# Access Compliance Report

## Public Rights-of-Way

### (Curb Ramps)

Intersection ID: 20660	Main Street: SANDY_PORTER_RD	Cross Street: STEELECHASE_DR	Location: NW
ADA ID: 077F70D2F7F4	Ramp Type: Perp	Initial Pass/Fail: Fail	Overall Compliance: No
		Severity Score: 12.5

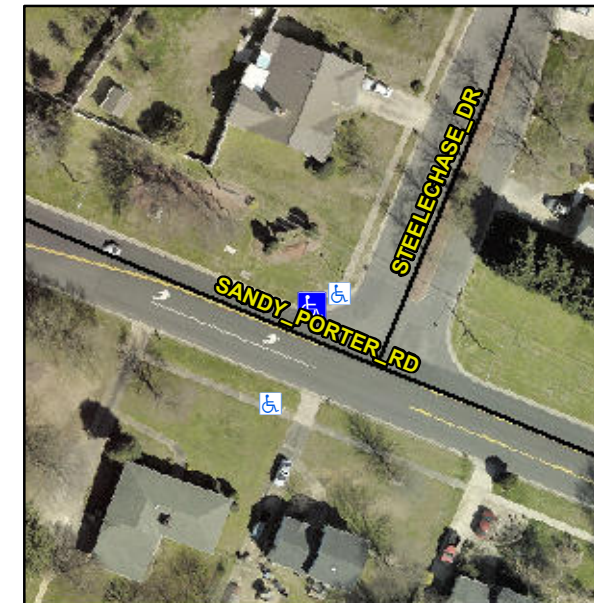
**R304.5.3**

Compliance	Description	Data	Compliance	Description	Data
N/A	Ramp Length (in)	95.0	Yes	Ramp Slope (%)	5.2
Yes	Ramp Width (in)	48.0	No	Ramp XSlope (%)	5.2
N/A	Flare Type LT	N/A	N/A	Flare Type RT	N/A
N/A	Flare Slope LT (%)	N/A	N/A	Flare Slope RT (%)	N/A
N/A	Flare Traversable LT?	N/A	N/A	Flare Traversable RT?	N/A
N/A	Landing Length (in)	N/A	N/A	DWS Provided?	N/A
N/A	Landing Width (in)	N/A	N/A	DWS Contrast?	N/A
N/A	Landing Slope (%)	N/A	N/A	DWS Length (in)	N/A
N/A	Landing X Slope (%)	N/A	N/A	DWS Full Width?	N/A
N/A	Landing Curb? (Y/N)	N/A	N/A	DWS Offset (in)	N/A
N/A	Shared Landing?	N/A			
N/A	Gutter Ponding?	N/A	N/A	Gutter Slope (%)	N/A
N/A	Gutter Lip Ht (in)	N/A	N/A	Gutter X Slope (%)	N/A
N/A	Painted X Walk1?	No	N/A	Painted X Walk2?	N/A
	X Walk 1 Direction	To SW		X Walk 2 Direction	N/A
N/A	X Walk 1 Width (in)	N/A	N/A	X Walk 2 Width (in)	N/A
	X Walk 1 Slope (%)	5.1		X Walk 2 Slope (%)	N/A
	X Walk 1 X Slope (%)	3.5		X Walk 2 X Slope (%)	N/A

**Remove & Replace Entire Ramp.**
